# Customer Notification

B-CN-080-EN Rev A

**SUBJECT:** Hardware Changes on TT and TG Series Compressors – Phase II

**Figure 1 – Impacted Items**

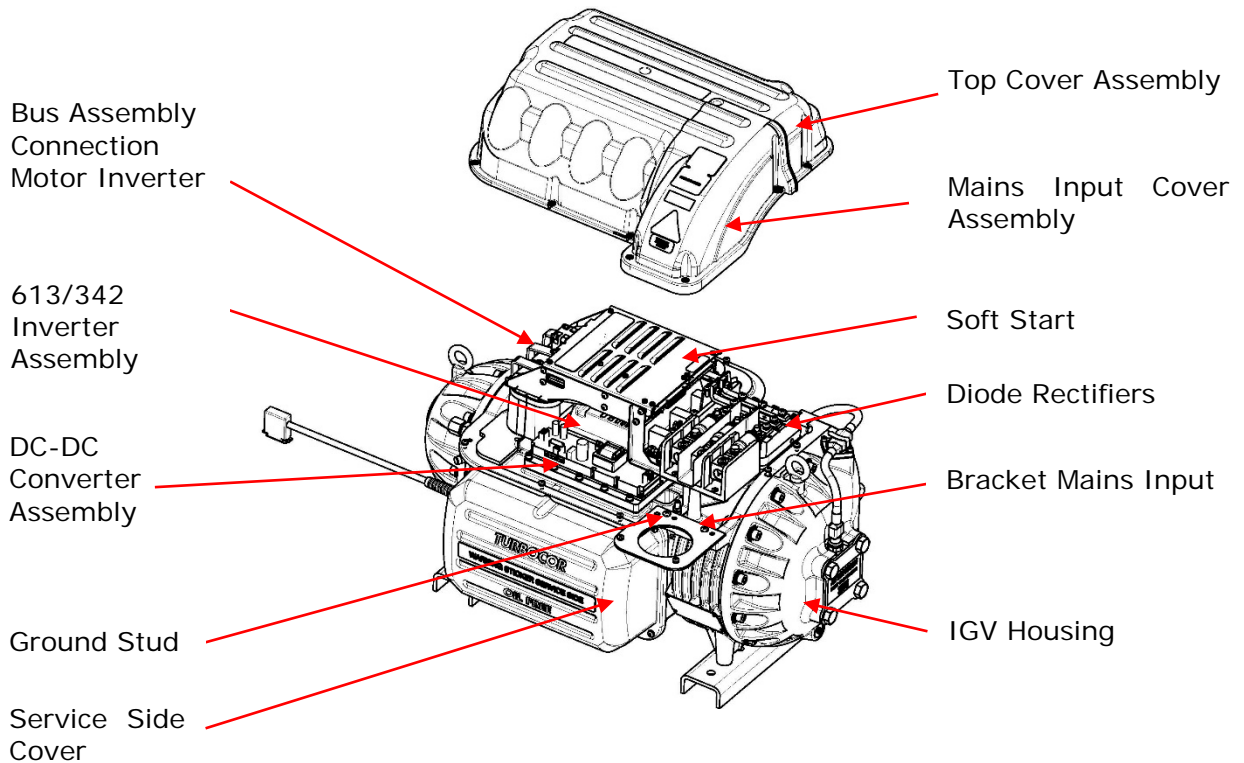
The hardware is being changed because, in some environmental conditions, corrosion can form on the hardware which gives a negative impression of product quality. In general, there is no functional impact as a result of the corrosion but there is an impact on the aesthetics.

**All new Turbocor compressor models and affected Spare Part Kits have been updated to use Stainless Steel in all areas.** The first phase of this effort was completed in February 2017. Phase II is involved with updating all of the remaining fasteners.

**Phase II** – Consists of changing all external hardware and hardware which has the potential to be exposed to condensation or external environmental conditions. Phase II necessitated a change to some of the hardware used in the following kits:

Some of the impacted items/kits are shown below in Figure 1.

Some screws with a Philips head will be changed to either a Torx (T25/T45) or hex head. However, there are no changes to the torque values of the impacted fasteners.
